Subject: Braidwood Generating Station Units 1 and 2  
 Masonry Walls  
NRC Docket Nos. 50-456 and 50-457

Response to NRC Request for Additional Information  
on Masonry Wall Design Based on Telephone  
Conversation Request From NRC of July 1, 1983  
Response to Braidwood FSAR Question 130.60

Braidwood Masonry Wall Crack Survey

WALL ELEVATION  
 PARTITION WALL 2A-41A  
 BRAIDWOOD STATION UNITS 1B2  
 COMMONWEALTH EDISON CO.  
 CHICAGO, ILLINOIS

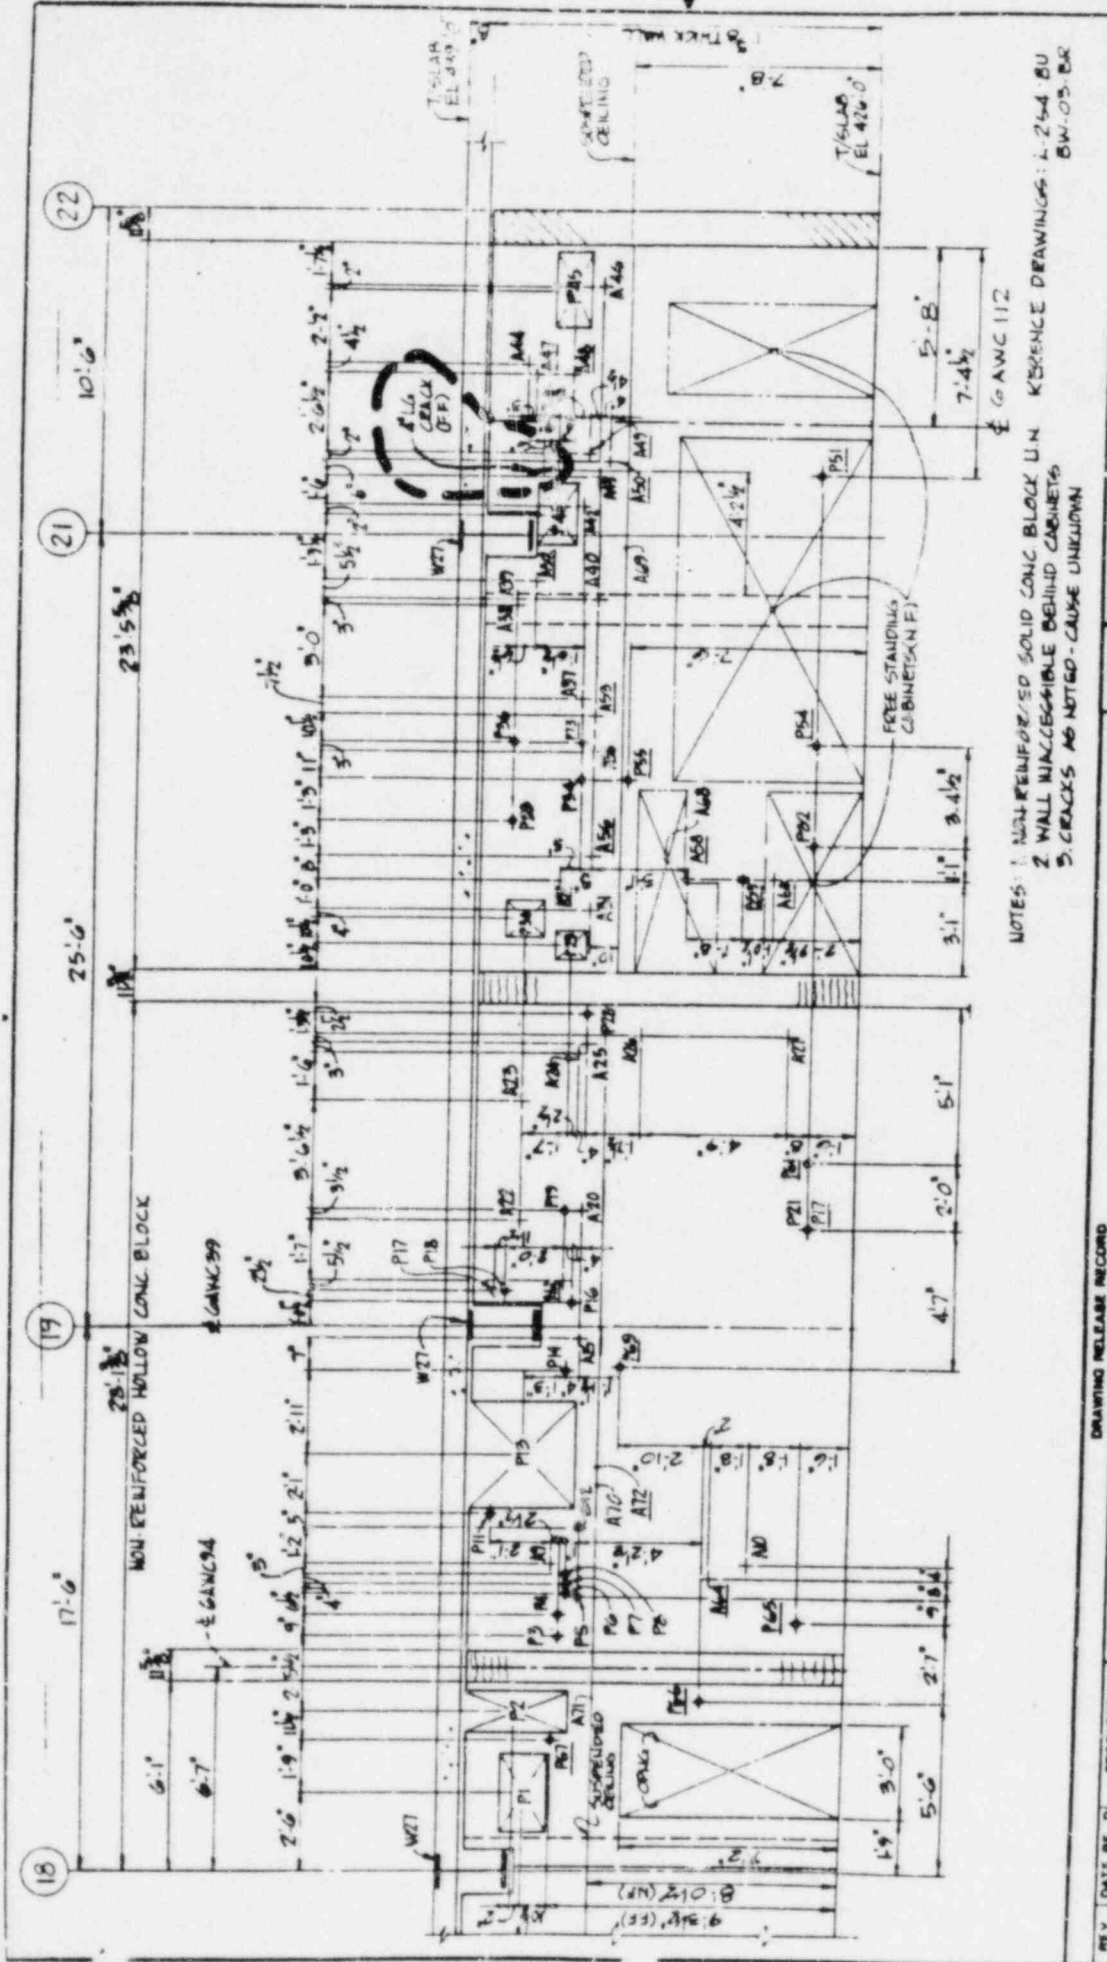
<u>Classification Of Crack</u>	<u>Wall Number (See Wall Sketch)</u>	<u>Design Impact of Crack</u>
1. Cracks at Lintels	SK-2A-41A SK-6A-31 SK-7A-11 SK-7A-14 (C1, C2, C3) SK-9A-01 (C1)	Expected crack at the joint or in the block at the lintel has little affect on the structural integrity of the wall.

WALL ELEVATION  
 PARTITION WALL 7A-11  
 BRAIDWOOD STA. UNIT 1&2  
 COMMONWEALTH EDISON CO.  
 CHICAGO, ILLINOIS

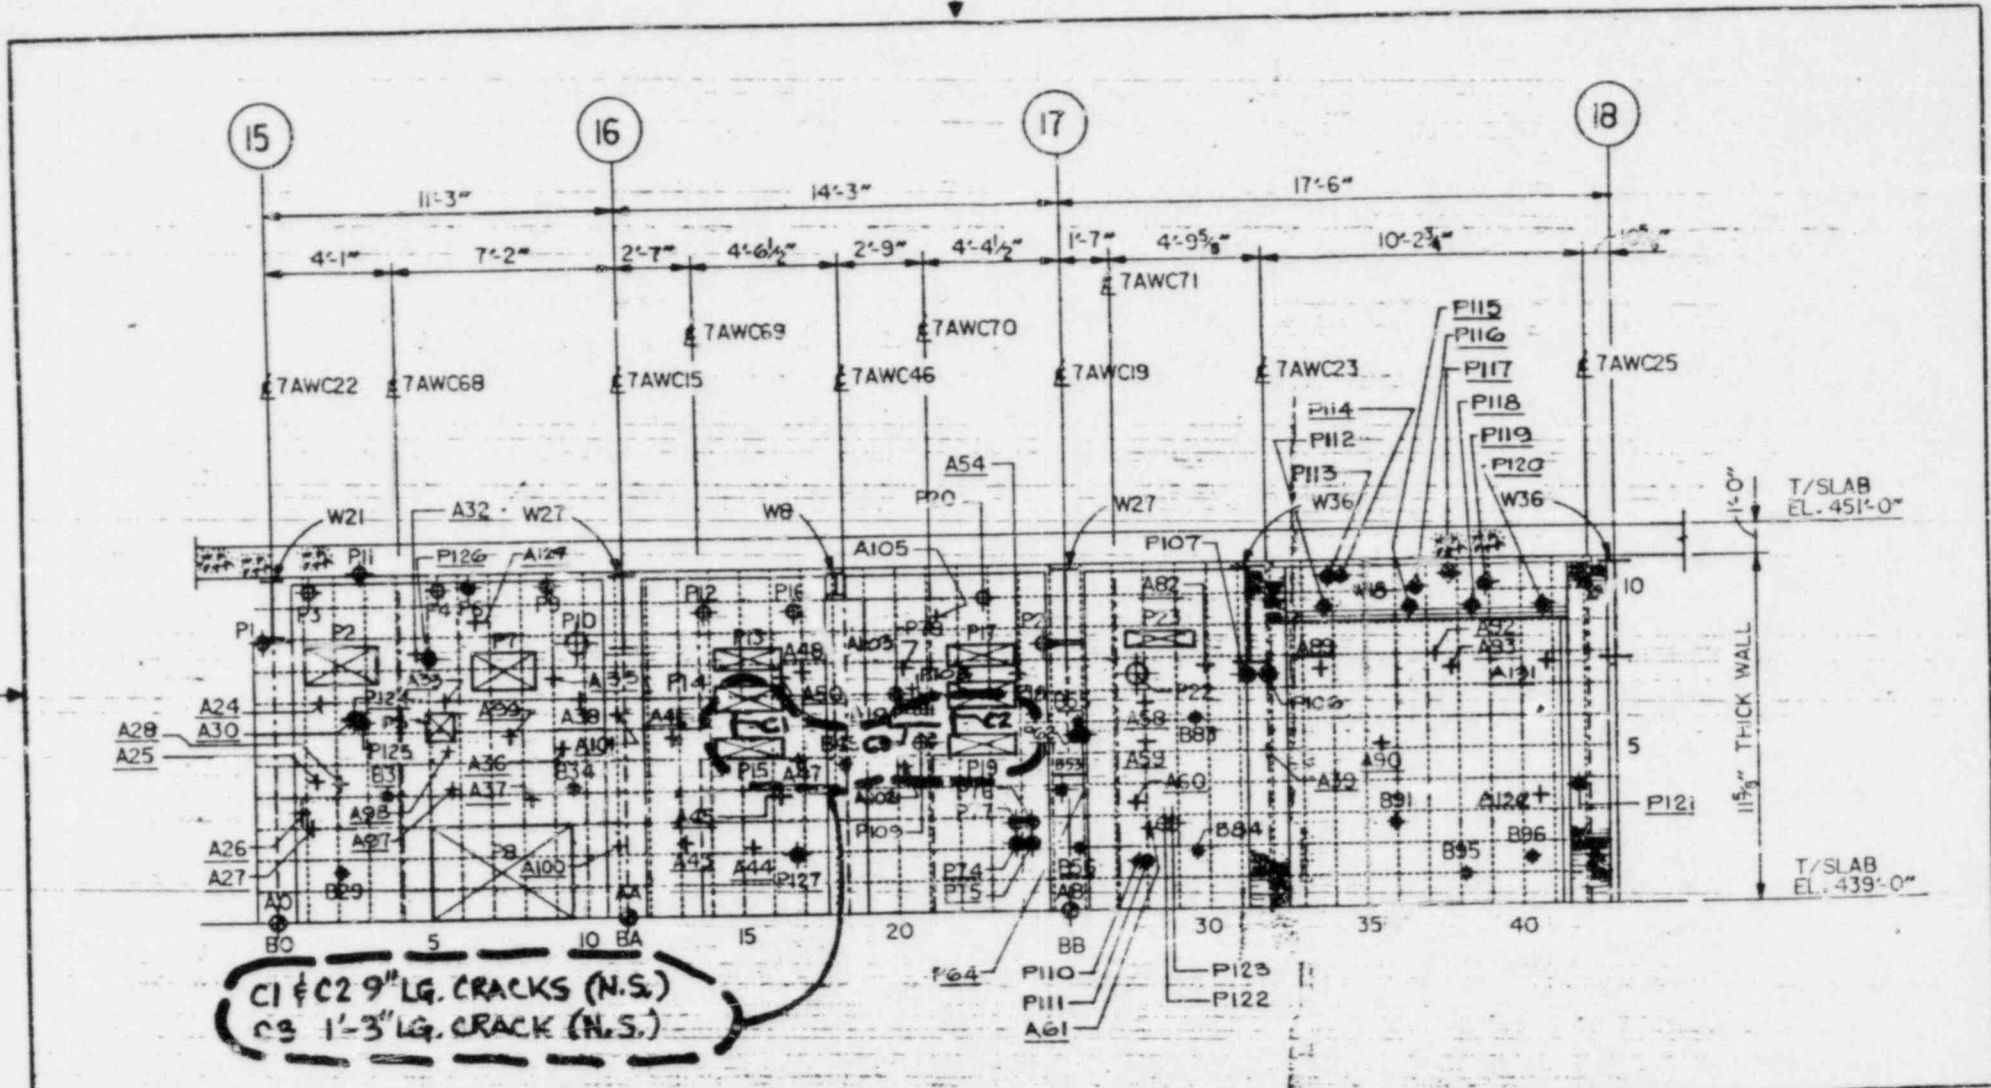
6" Long Crack (f.s.)

WALL ELEVATION  
 PARTITION WALL 7A-14  
 BRAIDWOOD STA. UNIT 1&2  
 COMMONWEALTH EDISON CO.  
 CHICAGO, ILLINOIS

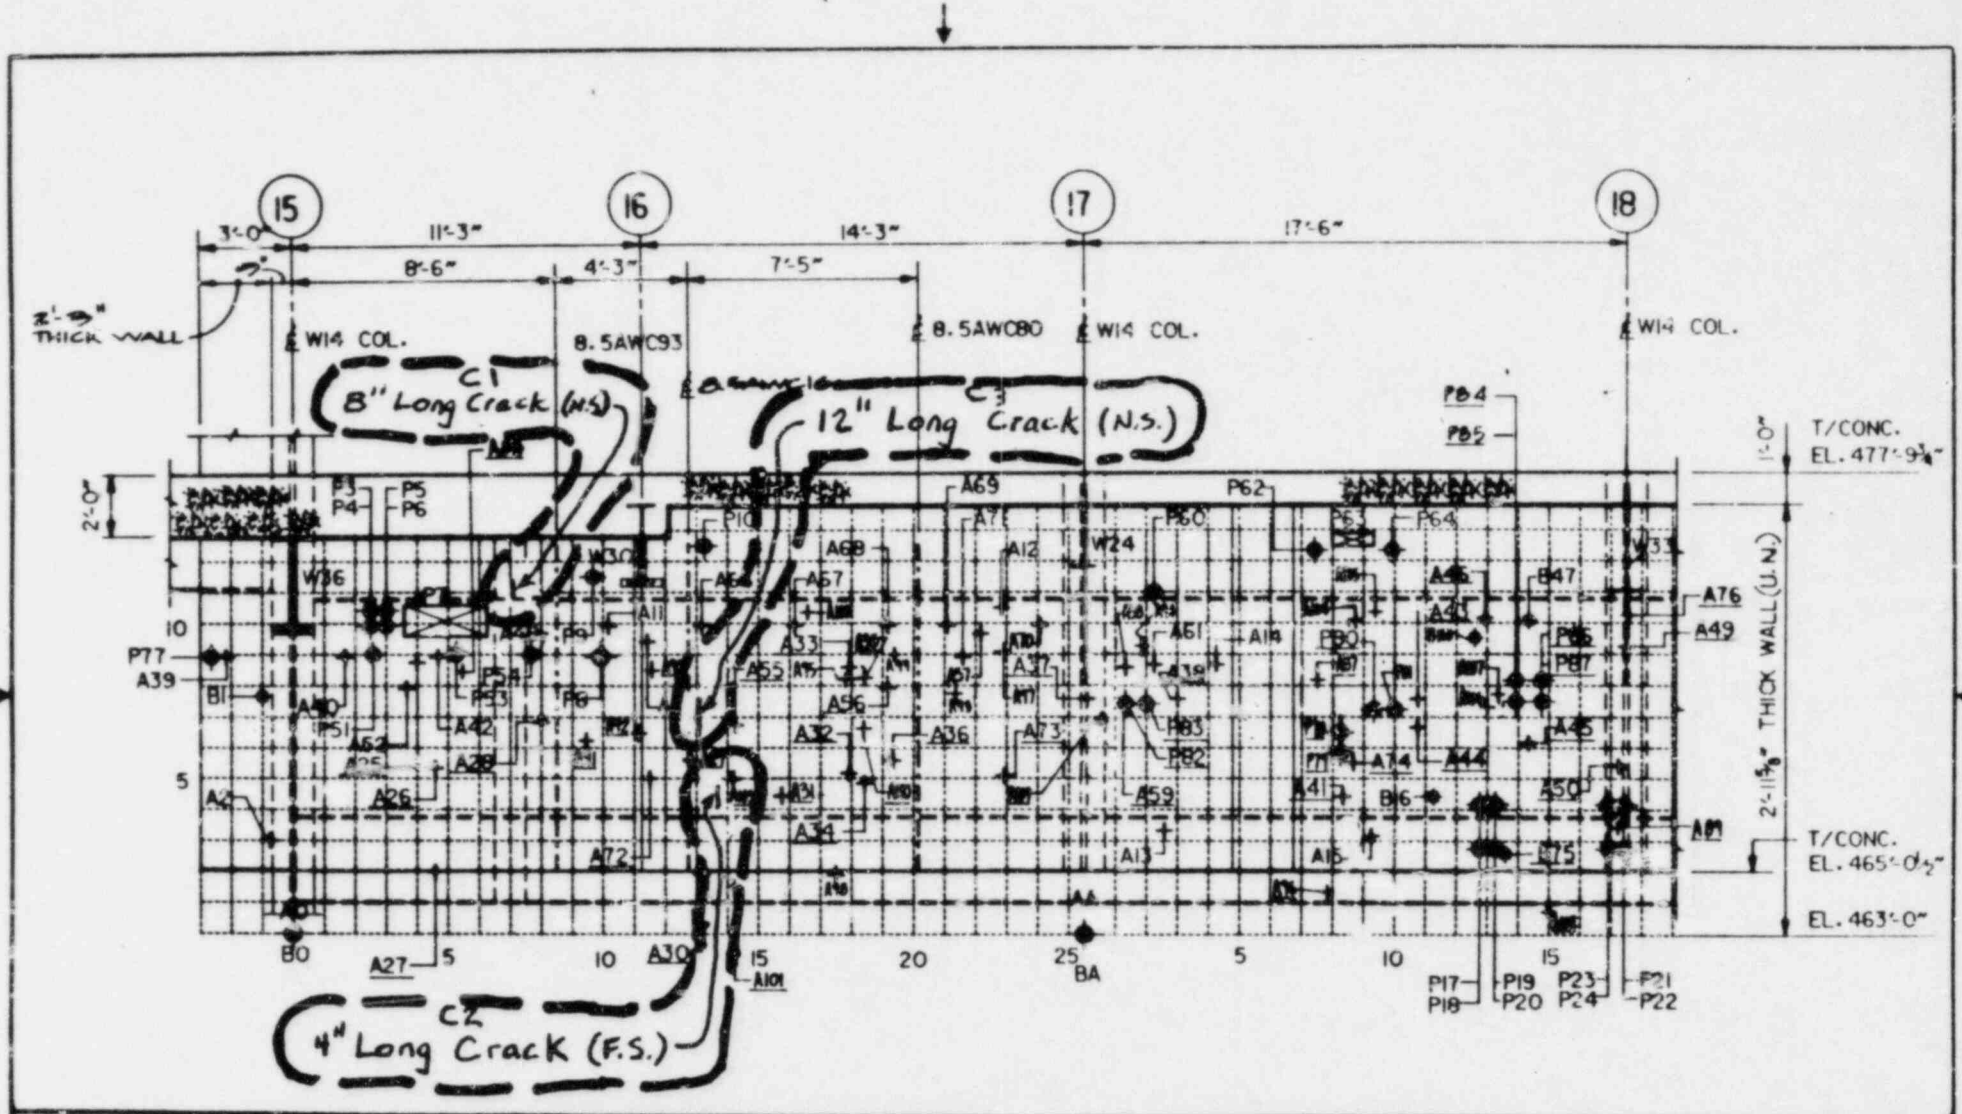
C1 & C2 9" LG. CRACKS (N.S.)  
 C3 1'-3" LG. CRACK (N.S.)

WALL ELEVATION  
 PARTITION WALL 9A-01  
 BRAIDWOOD STA. UNIT 1&2  
 COMMONWEALTH EDISON CO.  
 CHICAGO, ILLINOIS

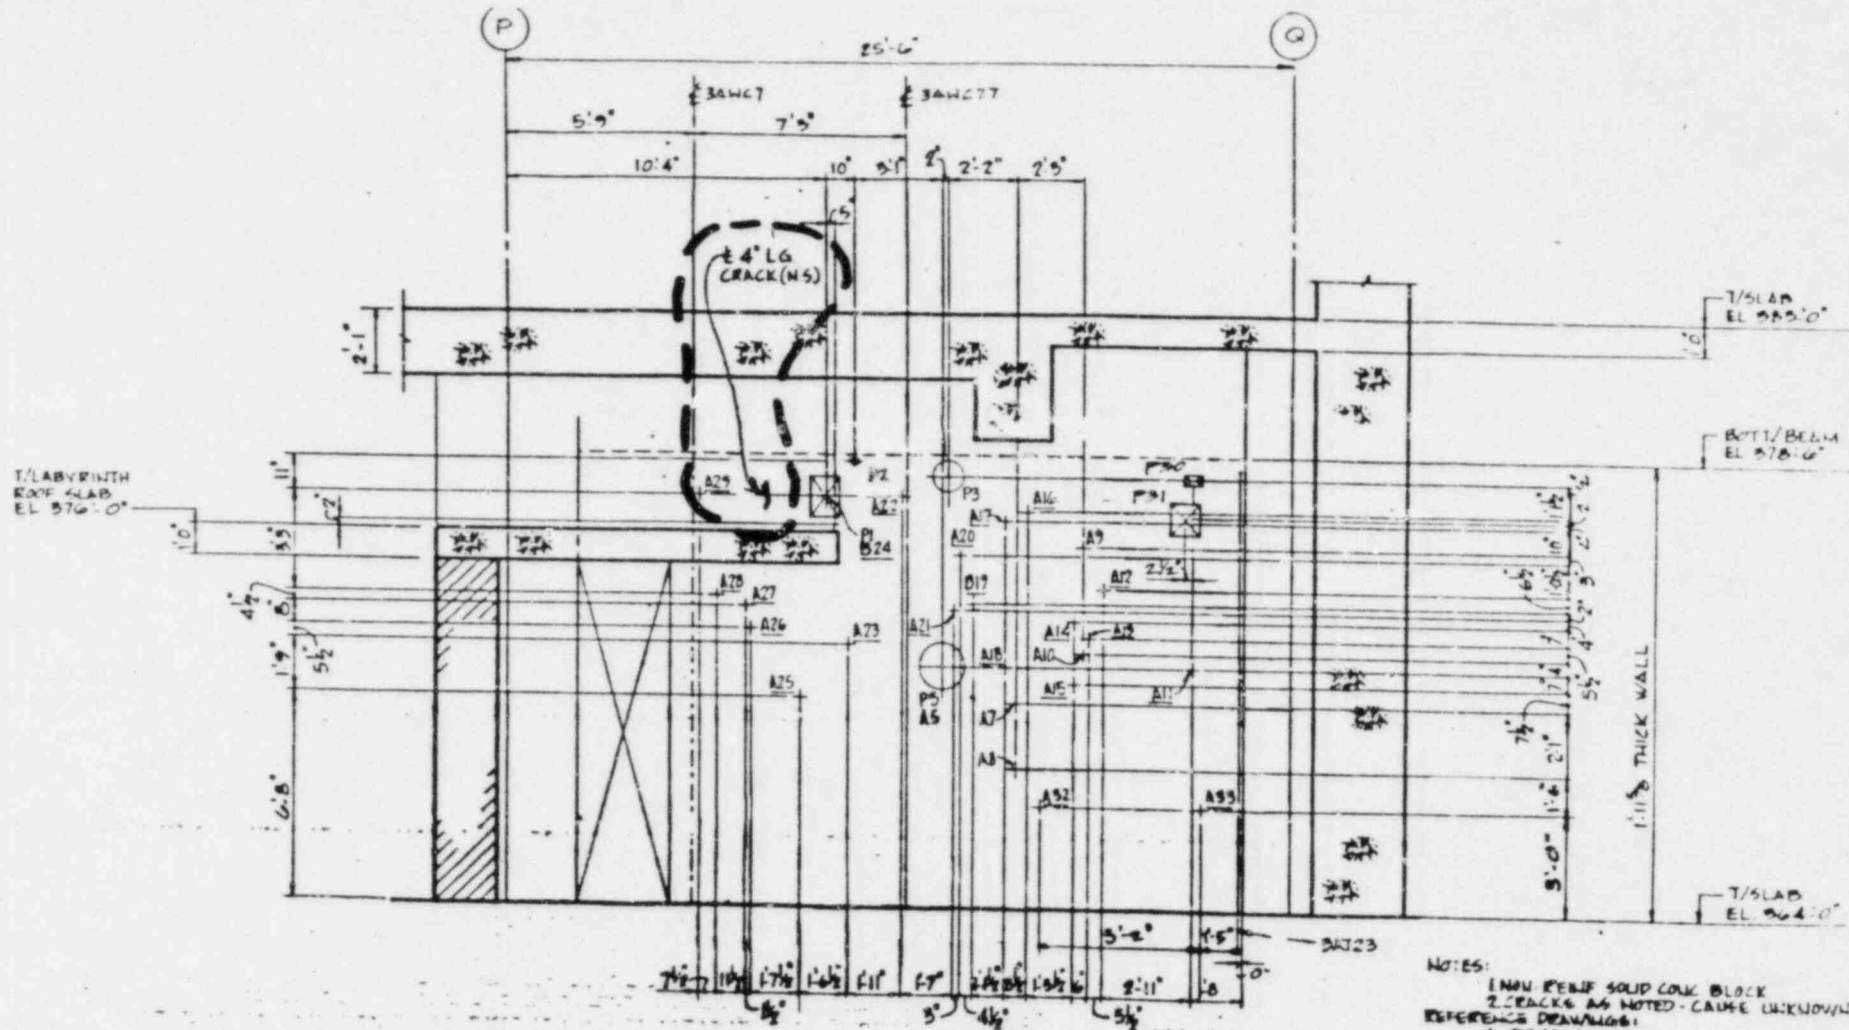
4. Vertical Cracks at Columns	SK-3A-34 (C1) SK-6A-81 SK-8A-03 SK-8A-30 (Cracks near column line 17 and column line 15) SK-9A-01 (C2, C3)	A modification has been installed at 8A-30's crack (located at 17 line) to ensure structural integrity. Walls 3A-34, 8A-30 (15 line), 6A-81, 8A-03, and 9A-01 (cracks C2 and C3) contain local non-thru vertical cracks at support locations (masonry wall columns or abutting wall). These cracks do not affect the structural integrity of the wall since the wall is assumed to span horizontally and the cracks are located at theoretical hinge points of simply-supported spans.

WALL ELEVATION  
 PARTITION WALL 3A-07  
 BRAIDWOOD STATION UNITS 1&2  
 COMMONWEALTH EDISON CO.  
 CHICAGO, ILLINOIS

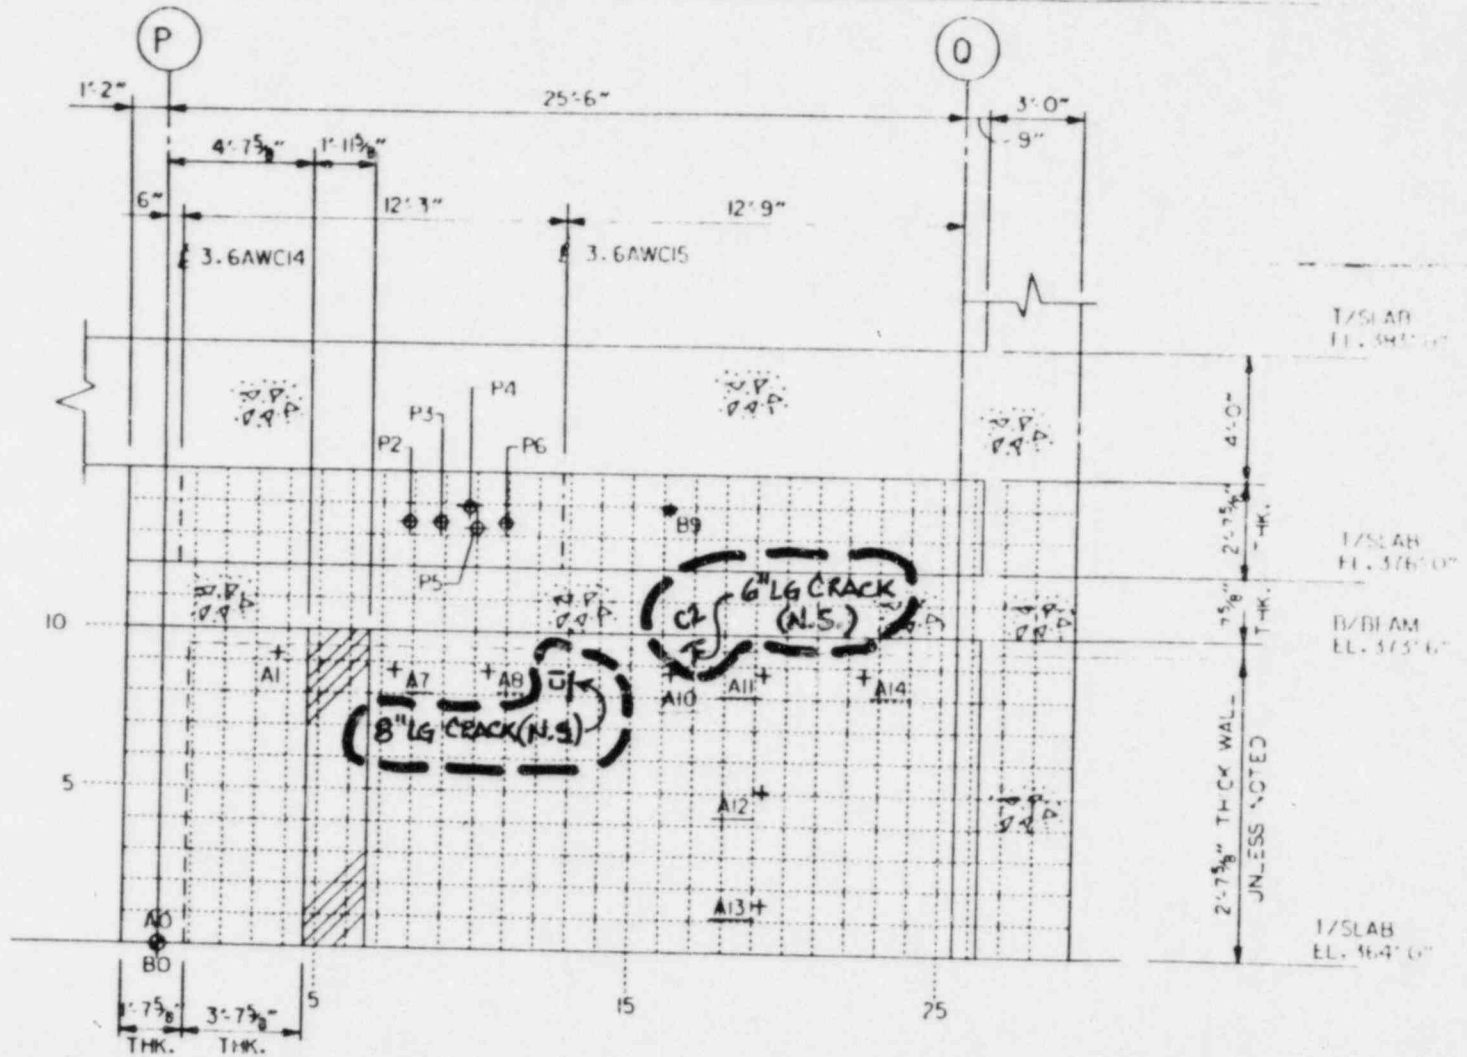
2. Vertical Non-Thru Cracks at the Top or Bottom of Wall Elements	SK-3A-07 SK-3A-34 (C2) SK-4A-86 SK-6A-68A (C1) SK-7A-03A SK-8A-26 SK-9A-07 SK-9A-18	Local cracks in one or two blocks at the top or bottom of the wall have no affect on its structural integrity.
